CUB CADET ENGINES (4-CYCLE)

Affected Models: 7T84JHA, 7T84JUA, T90BW
Affected S/N Range: Engine Serial number 7/2018- 7/2020
Affected Parts: 794-00136; 994-00136 Ignition Coil
Date: October 8, 2020
Subject: Cold No Starts or Sticking Choke Interference found

FIX-AS-FAIL

Figure 1

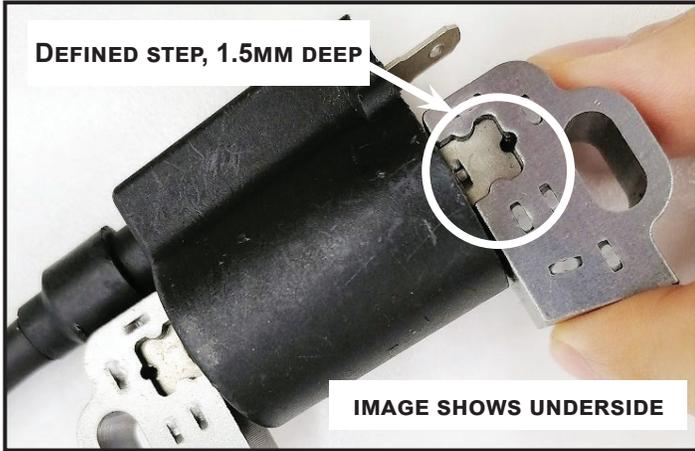
1. Identify a bad Ignition Coil. Remove Ignition coil from Engine. Turn over and inspect the underside. An Ignition coil with a 1.5mm step from the laminate core is a bad coil. See Figure 1.

3. When a bad ignition coil is found, it is in need of replacement. Order and install Ignition Coil 994-00136.

NOTE: To reinstall new coil: Set air gap of coil at 0.016"-0.024". Tighten the module mounting screws to a torque of 80-106 in-lbs (9-12 Nm).

Figure 2

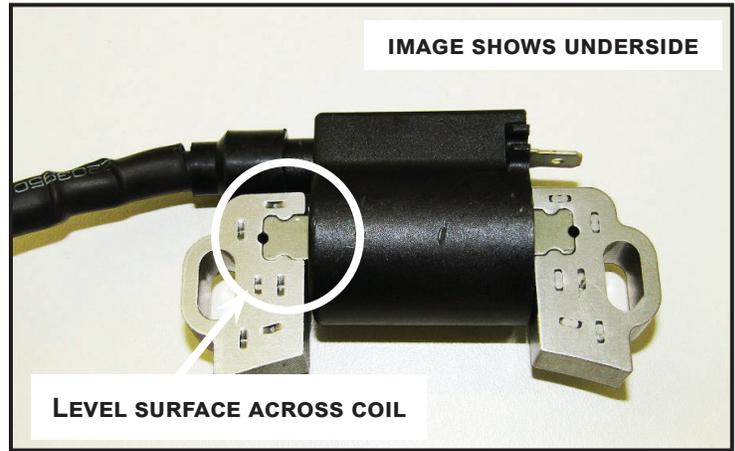
2. Identify a good Ignition Coil. A good coil will not have a step from the laminate core. See Figure 2.
